IEEE 802.3cd 100GAUI-2 to 100GBASE-DR Jitter Challenge

IEEE P802.3cd Task Force
Ad Hoc Meeting, October 2017

Casper Dietrich, Piers Dawe
Mellanox Technologies

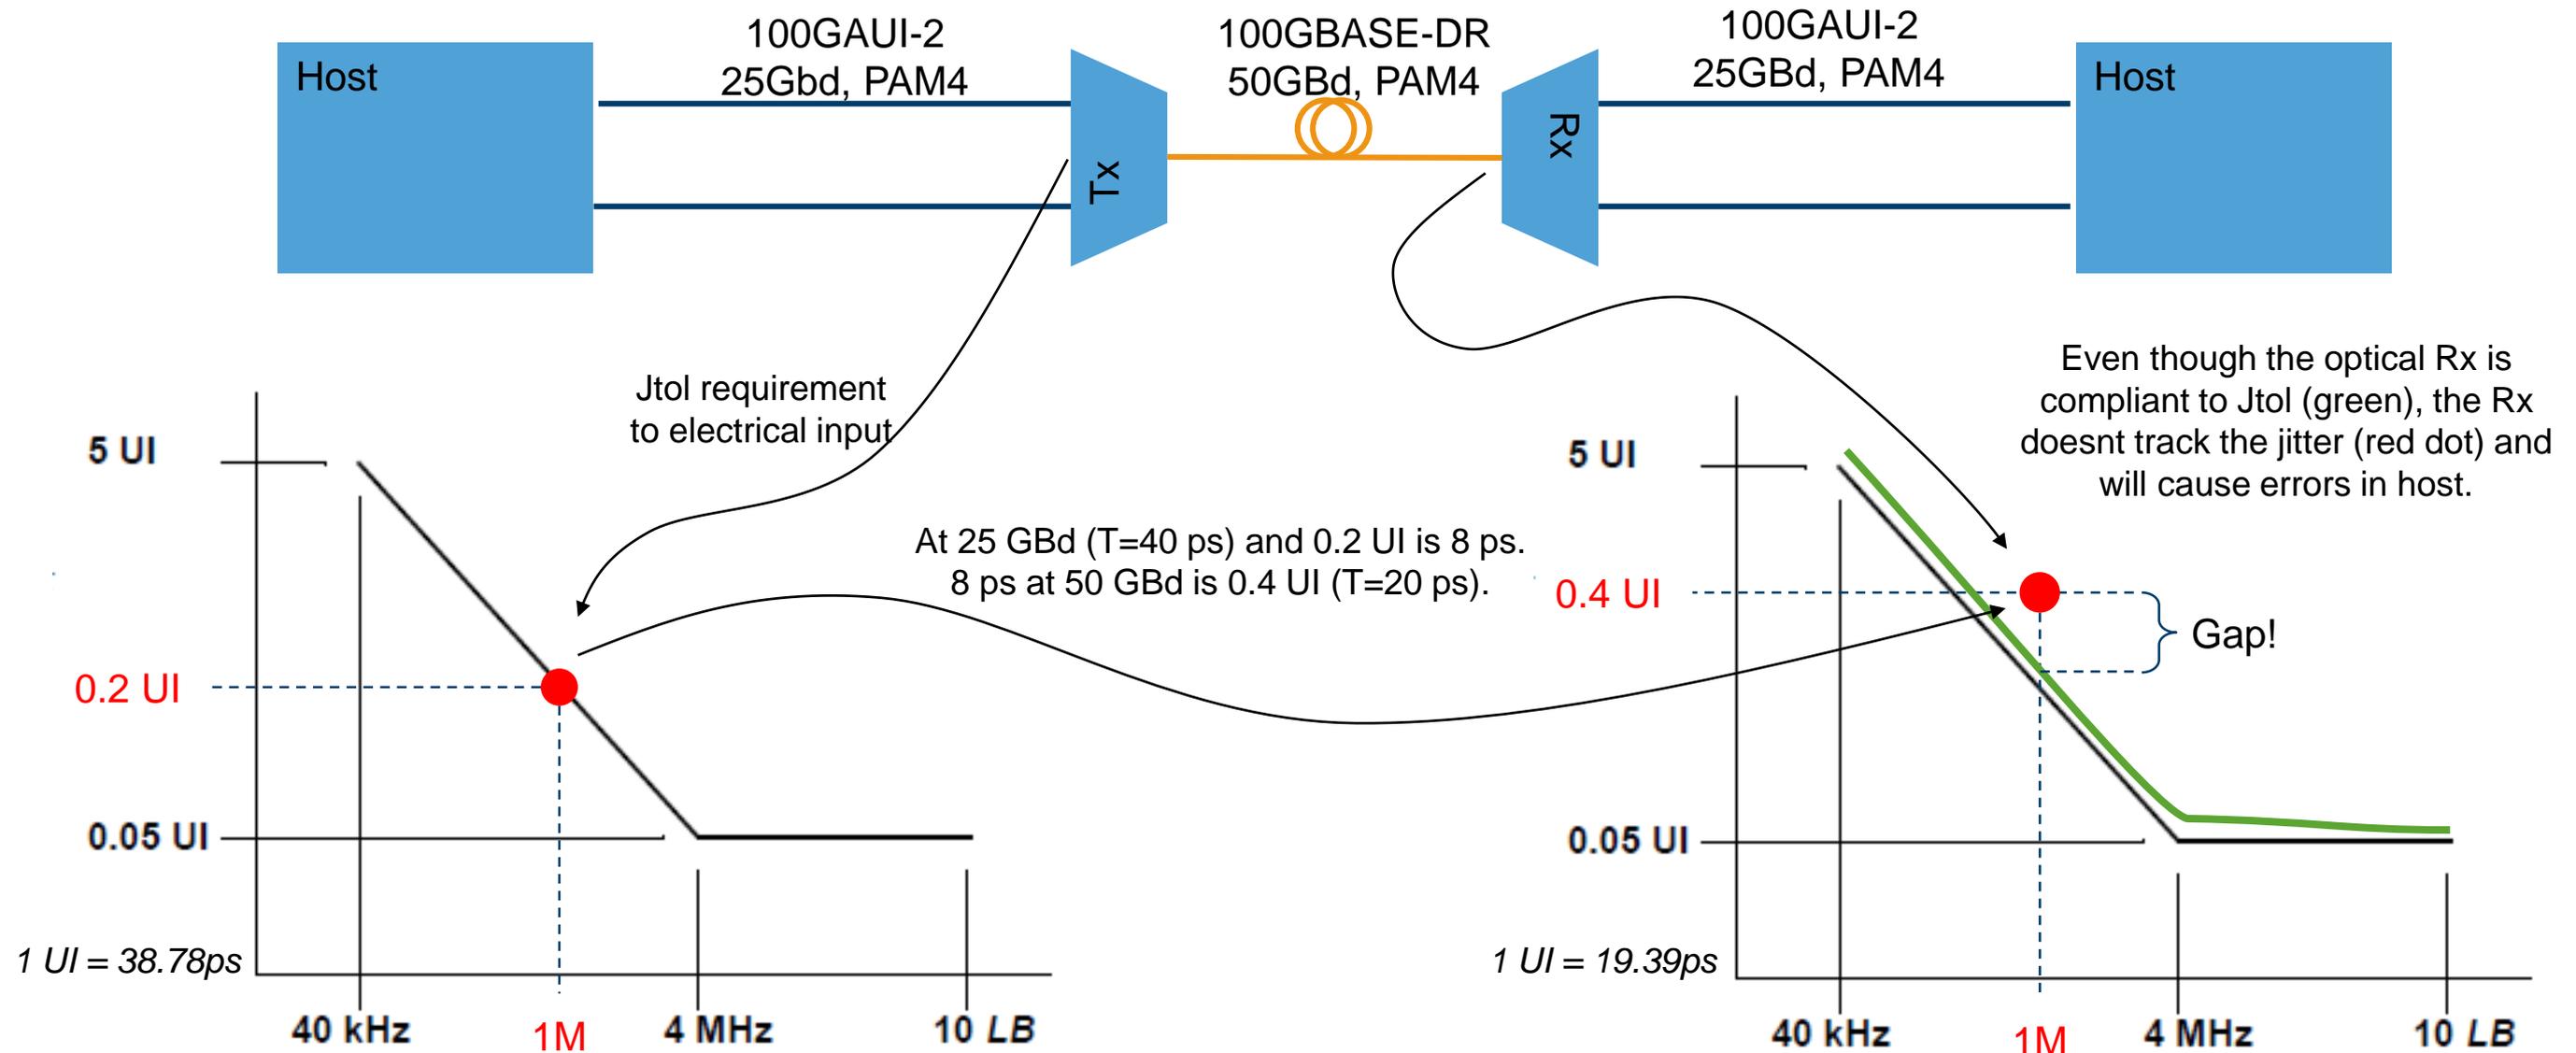
Concern:

The jitter tolerance mask is the same (in UI) for the AUI-8 electrical 25 GBd interface as for the optical 50 GBd receiver. But UI is different. In the worst case Tx will track the jitter with Jtol mask and the jitter at the optical 50 GBd will be doubled in terms of UI. An optical receiver Rx marginally compliant will not be able to track this and hence cause bit errors.
